The Detroit Edison Company
One Energy Plaza, Detroit, MI 48226-1279

October 19, 2010
NRC3-10-0046

Subject: Detroit Edison Company Response to NRC Requests for Additional Information (RAI) Letter No. 42 and RAI 02.04.13-11 of Letter No. 40

**Attachment 1
NRC3-10-0046**

Table 12.2-22R Radiation Source Parameters (Sheet 2 of 2)

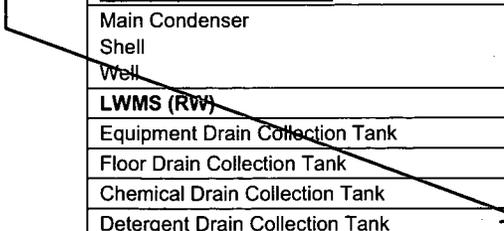
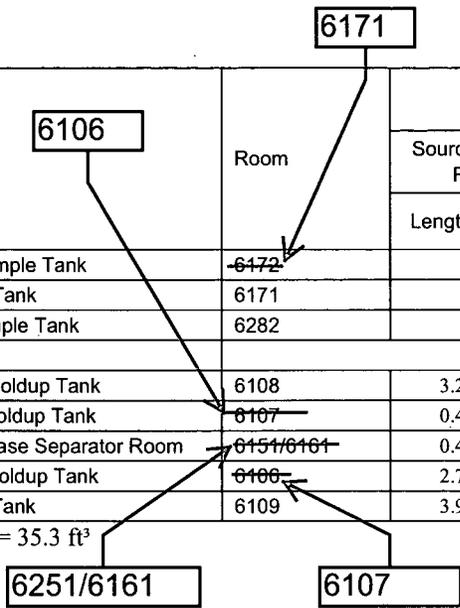
Replace Table 12.2-22 with Table 12.2-22R.
